## Technical Service Bulletin

| <b>Topic</b>           | New Continental GT - Ski hatch difficult to latch/unlatch |
| <b>Transaction No.</b> | 2052208/4                                                 |

Figure 2

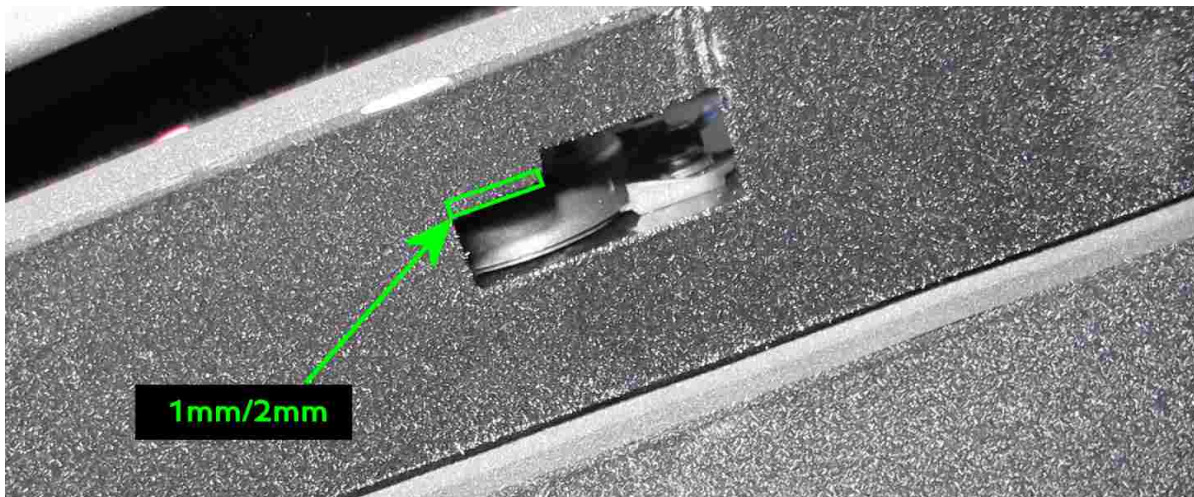
- Referring to Figure 2, Using a suitable tool initially remove up to 1mm from the trim and retest
- In the event the hatch does not close remove a further 1mm from the lock trim and retest
